Town of Hilton Head Island  
**Planning Commission Meeting**  
**Wednesday, June 21, 2023, 2:00 p.m.**  
**AGENDA**

**TO:** Planning Commission  
**FROM:** Trey Lowe, Senior Planner  
**VIA:** Missy Luick, Assistant Community Development Director  
**VIA:** Brian Eber, Development Services Manager  
**DATE:** June 21, 2023  
**SUBJECT:** SUB-000716-2023 107 Leg O'Mutton Cottages

## PLAN CORRECTIONS REPORT SUB-000716-2023

**SHEET C401**

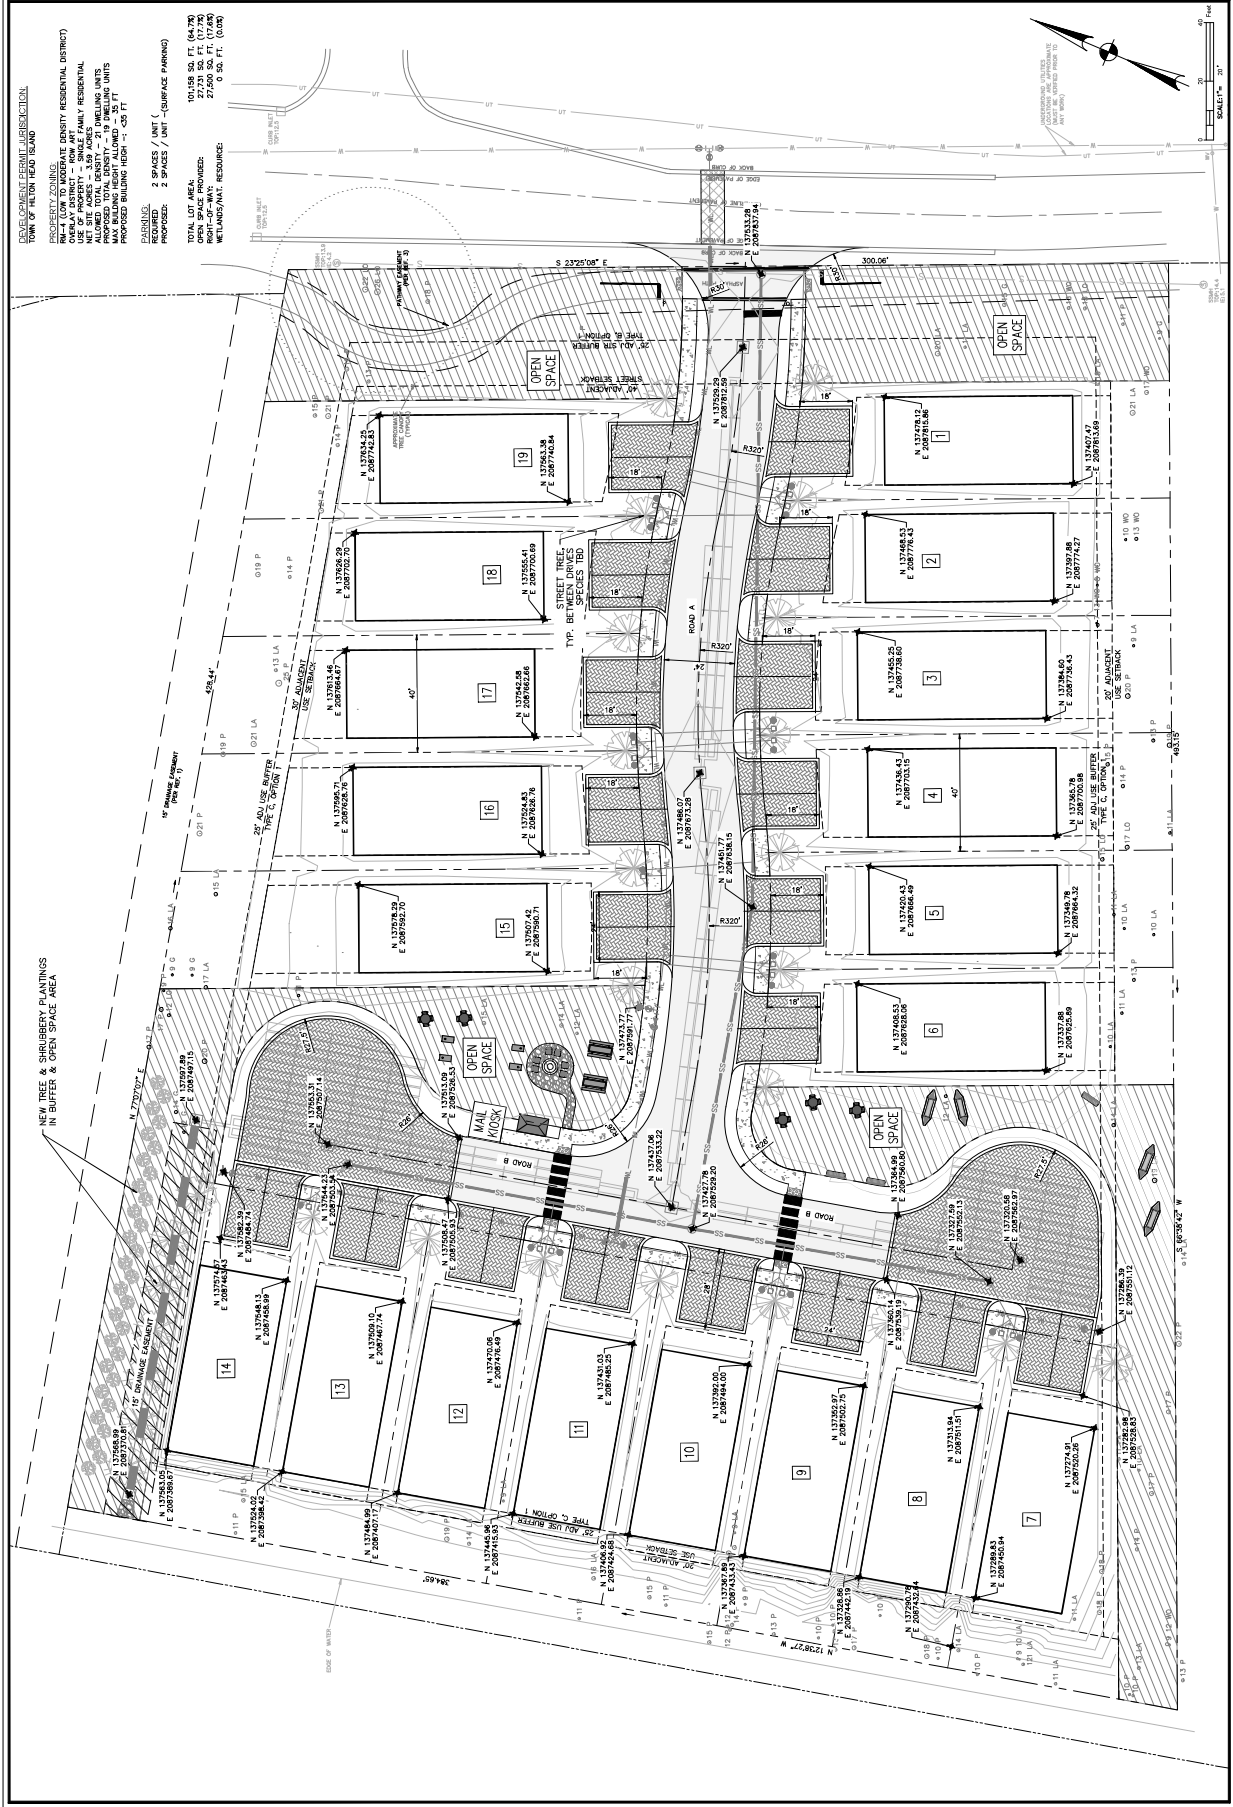
- 8) LMO Section 16 5 107.E.1 - Standard parking spaces must be 9' wide and 18' long. Show the parking dimensions on the plans. Also, LMO Section 16 5 107.F.1.a - Off-street parking areas shall be arranged for convenient vehicular access between an adjacent street and all parking spaces to facilitate ease of mobility, ample clearance, and safety of vehicles and pedestrians. Each off-street parking space shall have adequate and unobstructed means for the ingress and egress of vehicles. Please adjust parking areas so that the required 18' length does not encroach onto the multi-purpose pathway.

- 9) Show all building and site improvements on the plan, including HVAC units, utility equipment and pedestals, and stairs. No improvements are permitted within buffers. Please show the proposed location of the HVAC equipment.

- 15) A minimum of one fire hydrant shall be located within 500 feet of all portions of the building – depending on the required fire flow additional hydrants may be required. The hydrant locations are not approvable based upon use during response. The hydrants should be located on the route to homes not at the end of the line.

SHEET  
NUMBER  
L-100

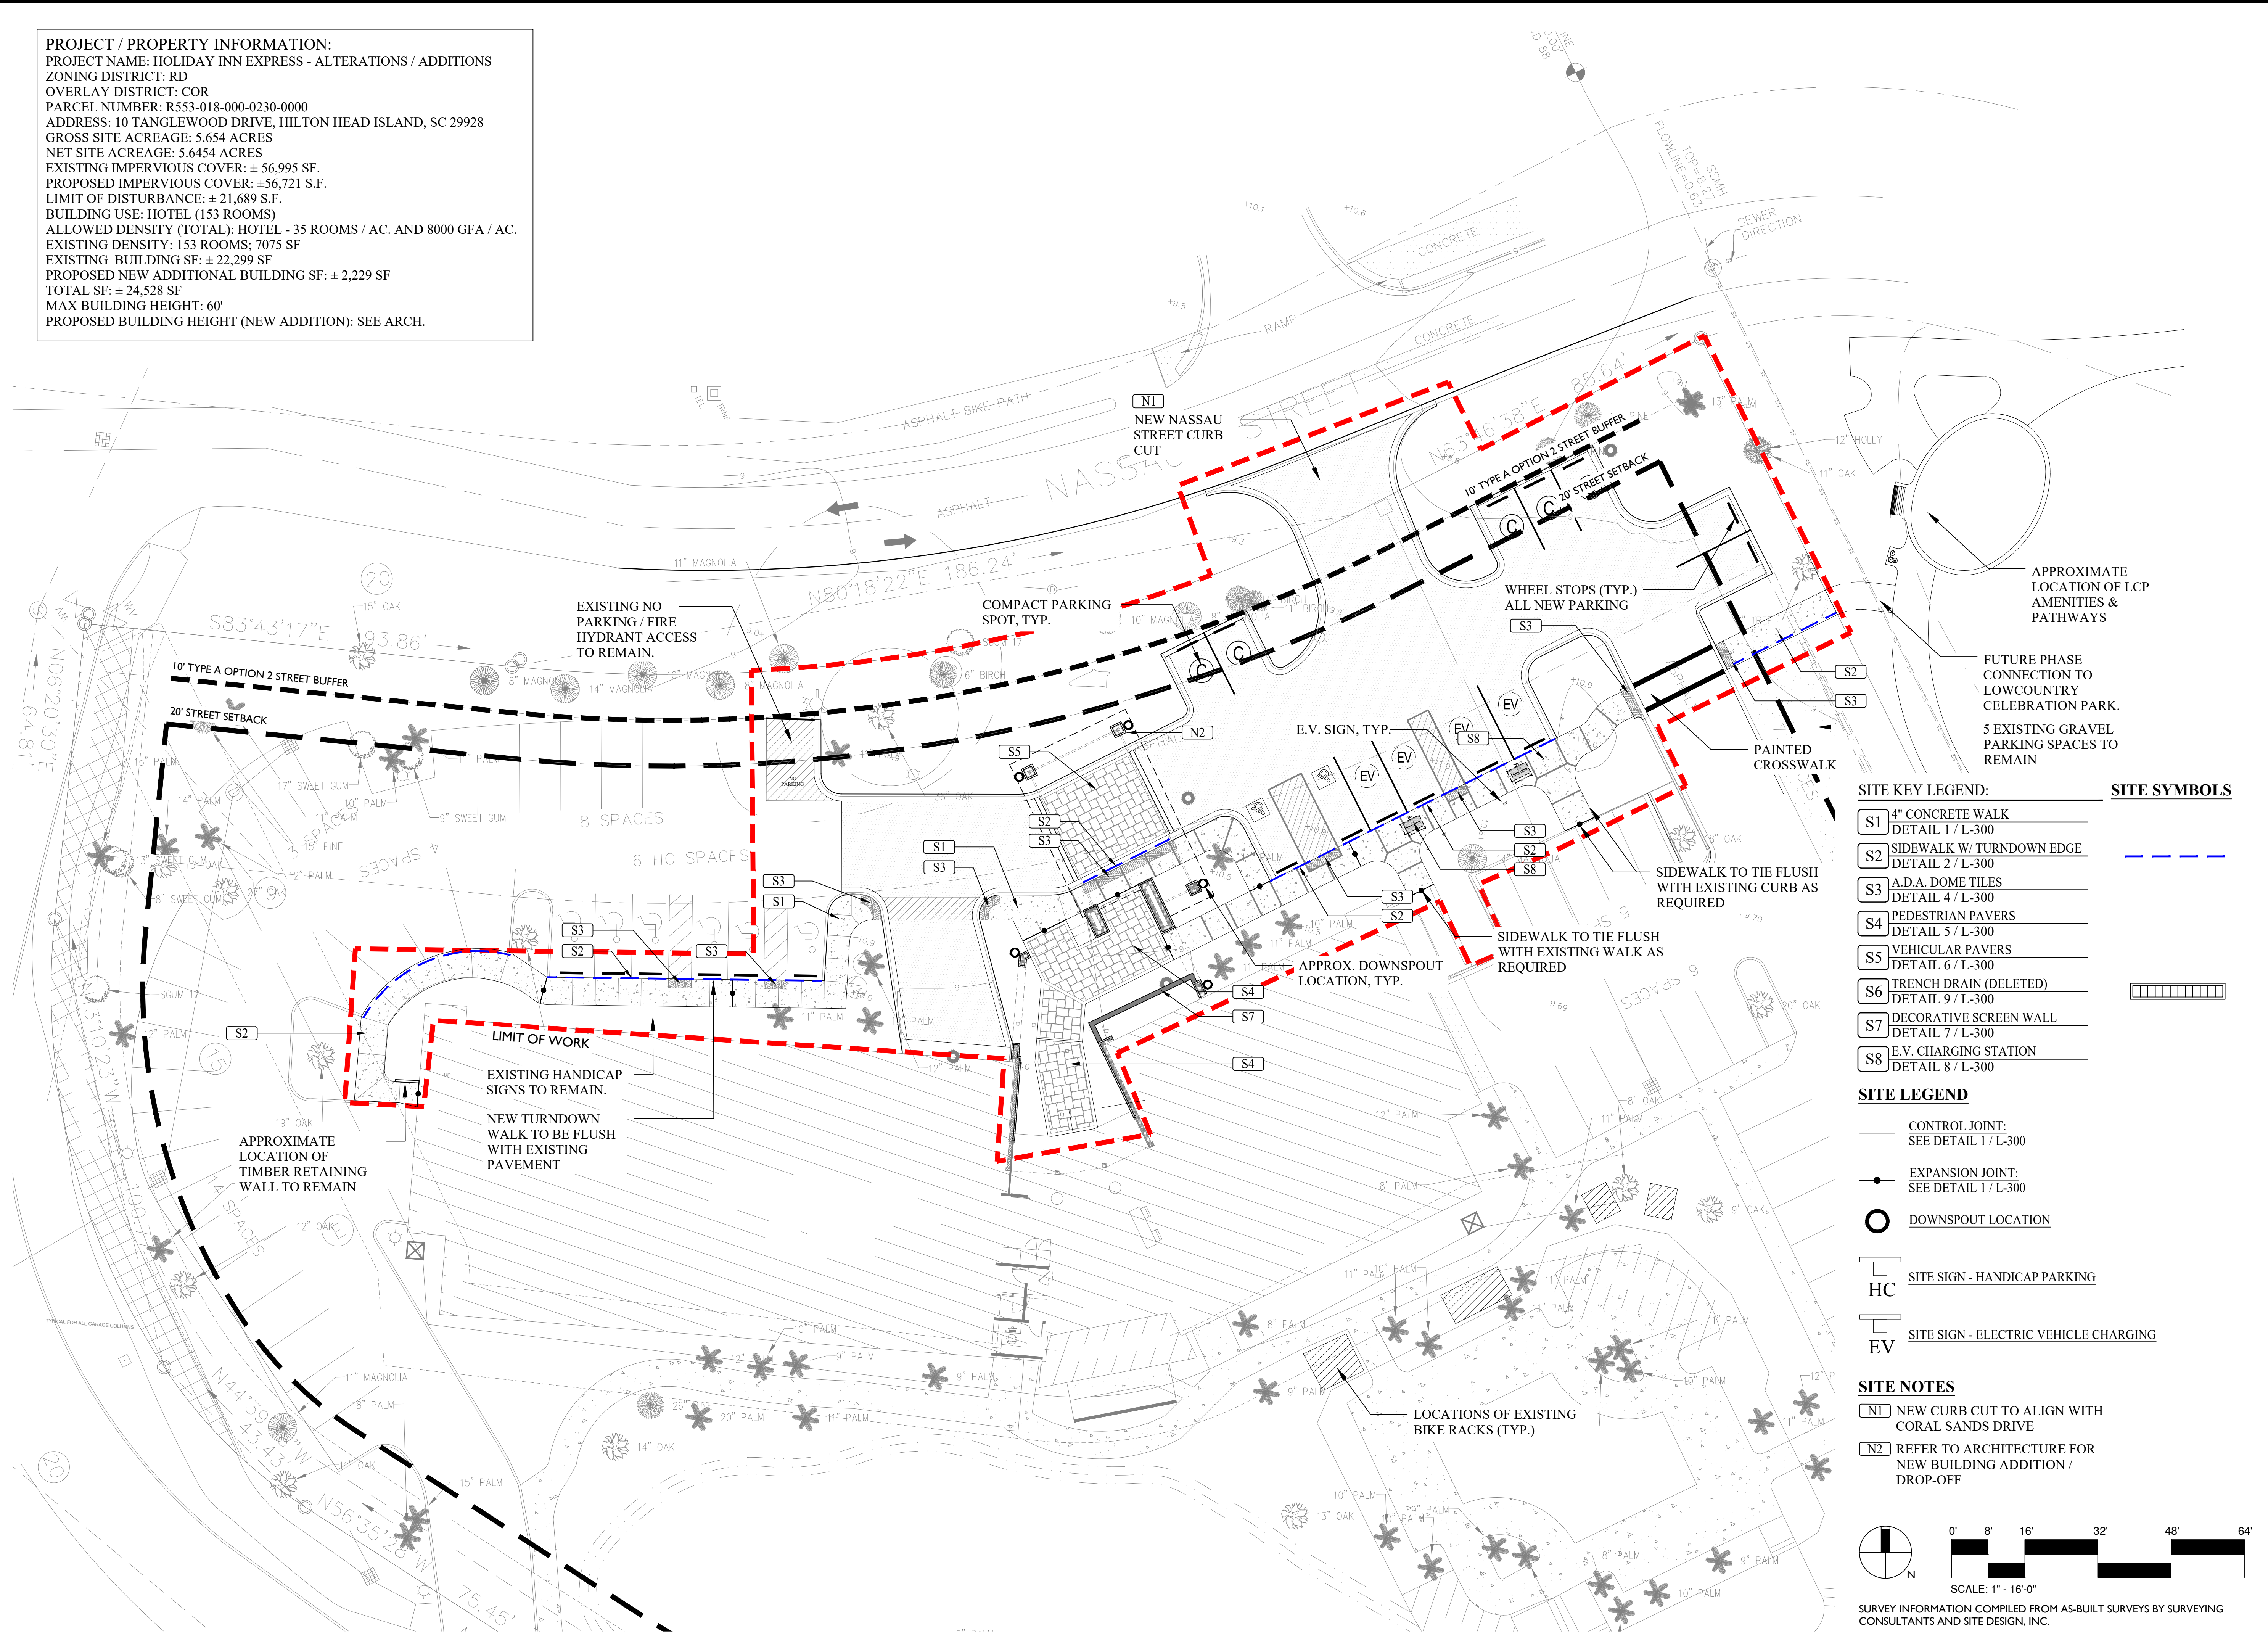
- 5) LMO Section 16 5 108.C.3 - Fixtures must be mounted in such a manner that the cone of light does not cross any property line of the site. The site lighting plan shows light trespass over the subject property's property line which is not permitted. Please have Palmetto Electric adjust the lighting plan so that there is no light trespass.

- 7) Please show autoturn for fire apparatus especially in the new entrance and along the north side of property

- 8) Provide traffic control (signing, marking, etc.) plan, including any required or anticipated street name sign installations, any required to serve one-way facilities, and/or any needed to safely control new or enhanced access crossings of Town pathways. Page 6 of plans, bottom of sign height according to MUTCD is 7 feet.
- 9) Drive aisles and/or backing areas do not satisfy minimum and maximum widths in 16-5-107.E.2. Aisle width shall be 24 feet wide for 90-degree parking.

PROJECT NUMBER	SC103-0401
SHEET NO.	C1.0

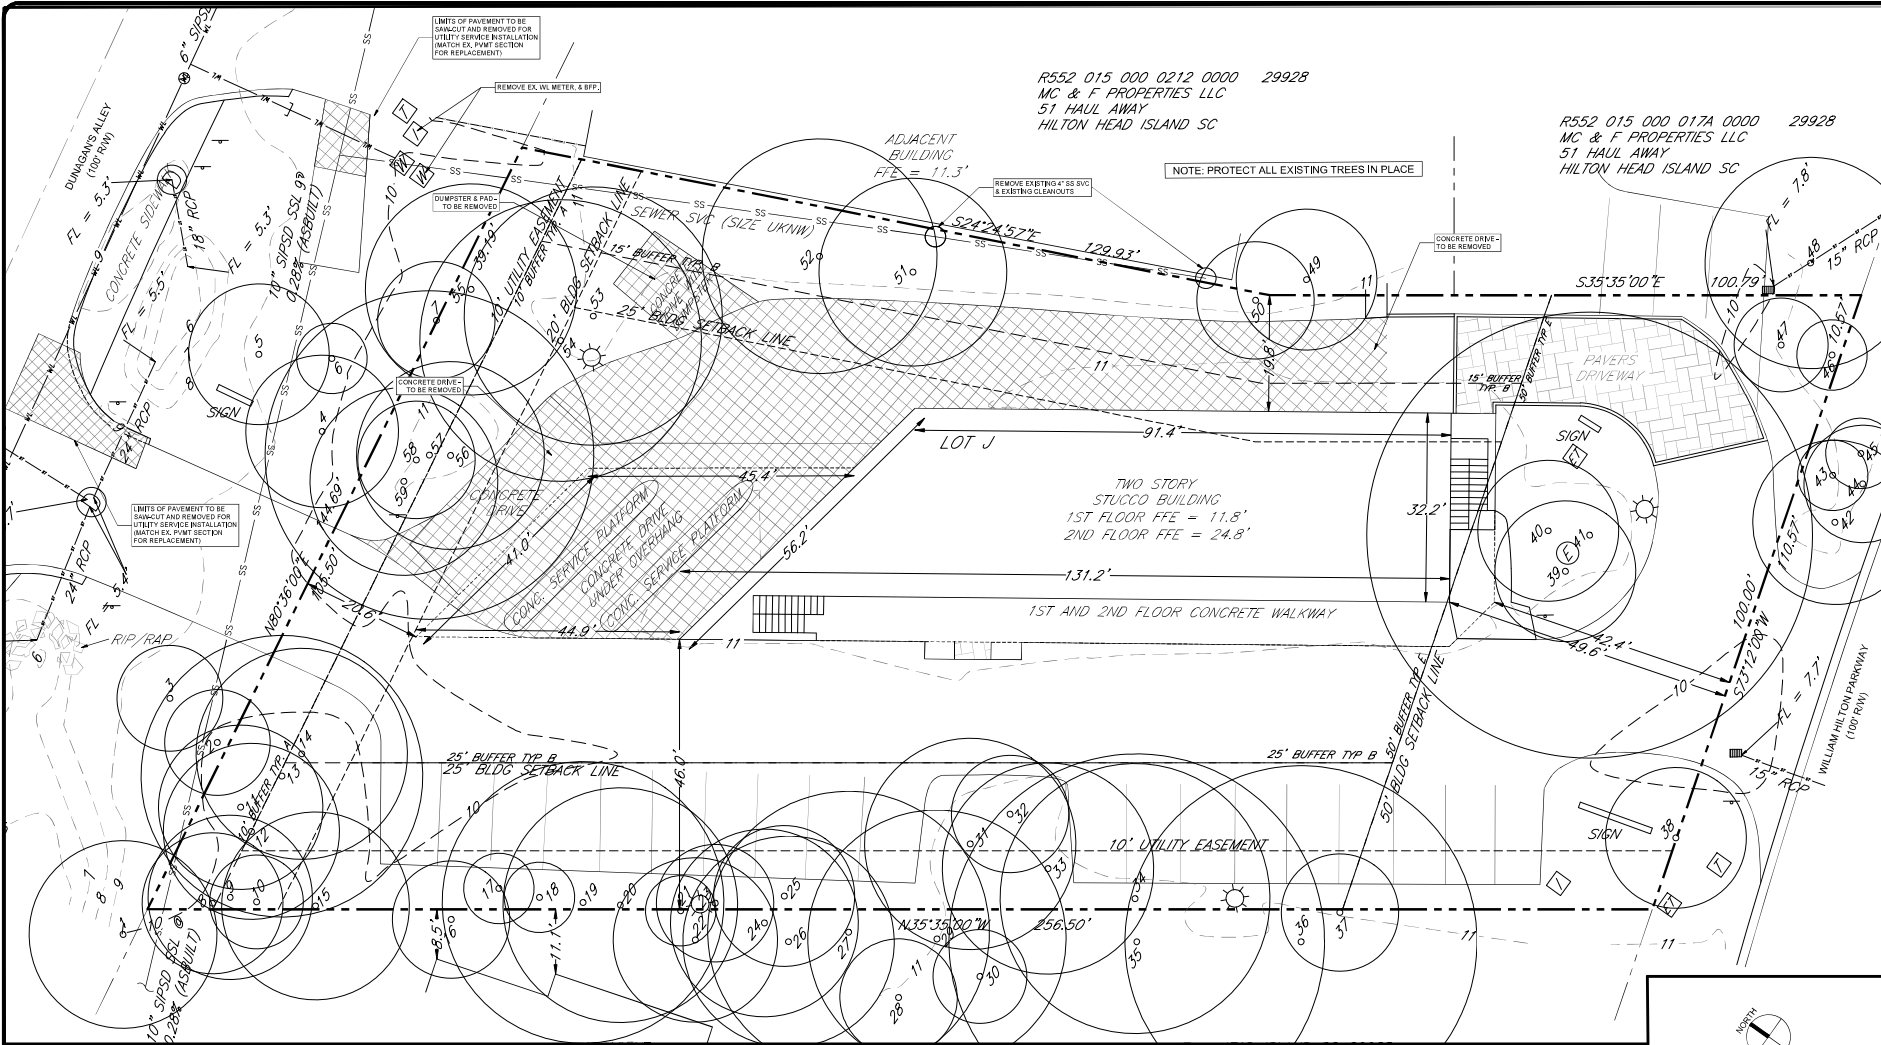
16. On Sheet C1.0 the existing trees will need a pre and post construction fertilization plan with a Mycor treatment need to be completed by a certified arborist where the soil will be disturbed with the asphalt removal and new pavers are installed in an effort to preserve the trees.

PROJECT NUMBER: 60185-0401  
 SHEET NO.: **C4.0**

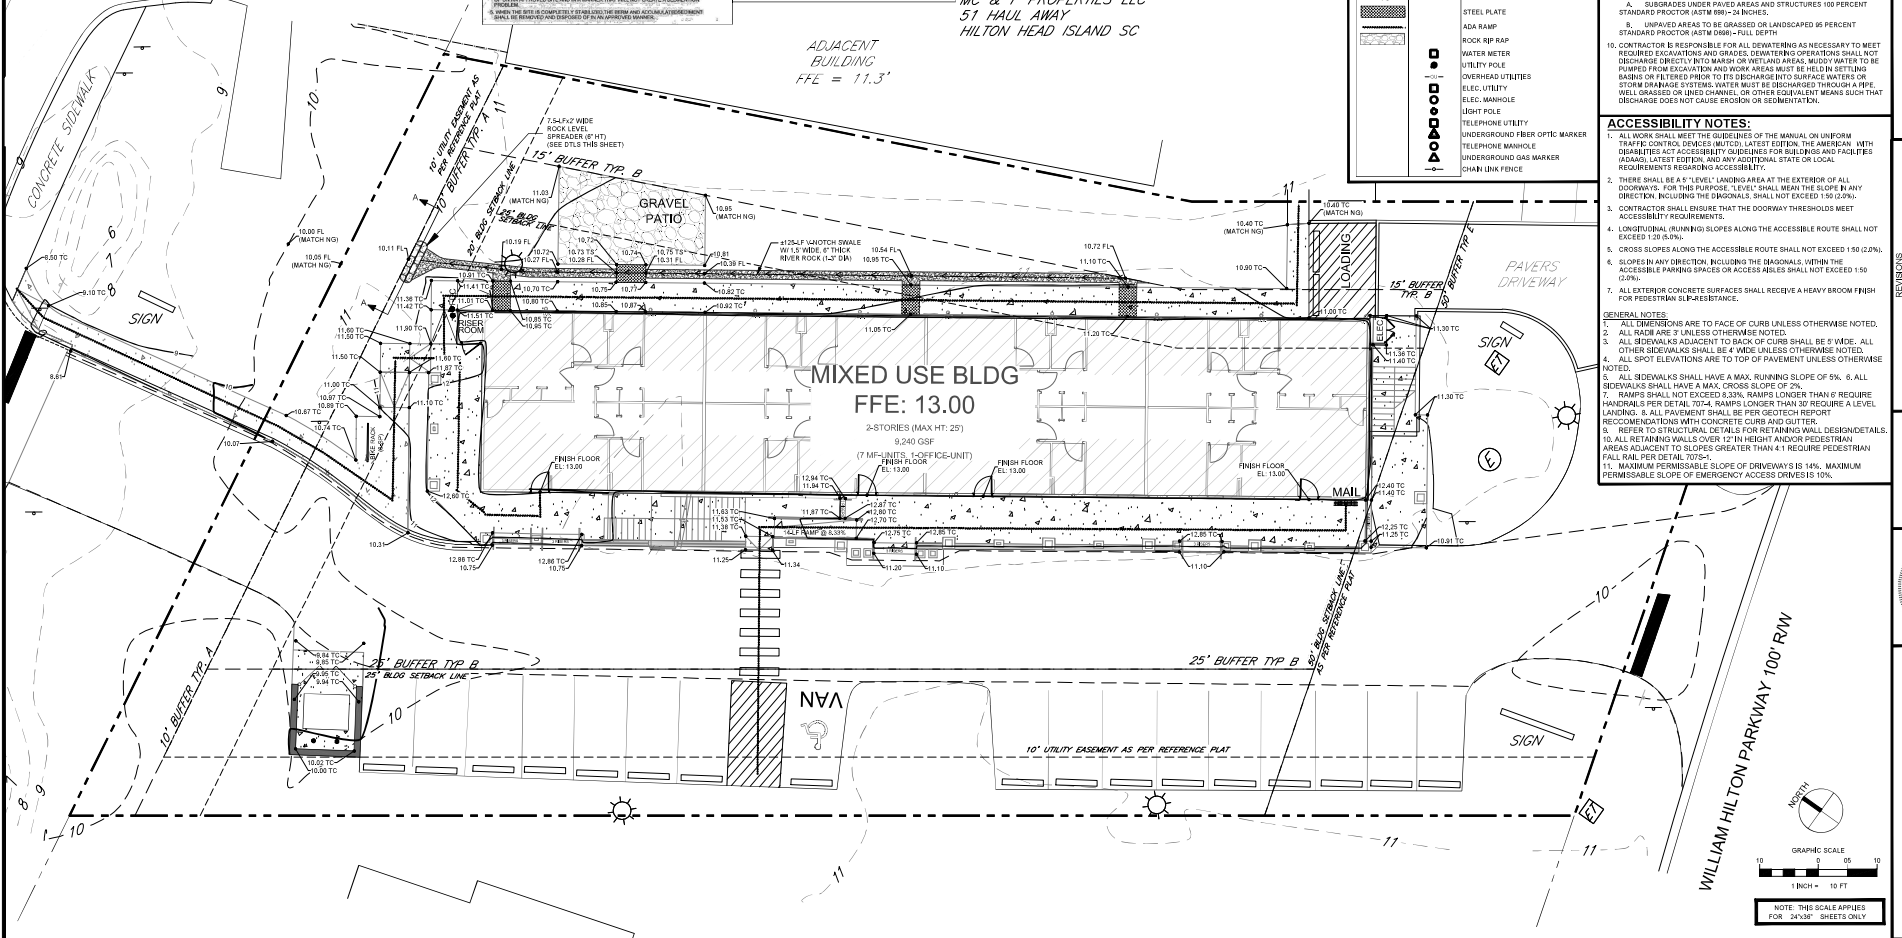
13. Plans include a detail for a level spreader. Indicate where this is to be installed on the plans. Grading plan shows a shallow swale that passes through the middle of a gravel patio. Is this the design intent?
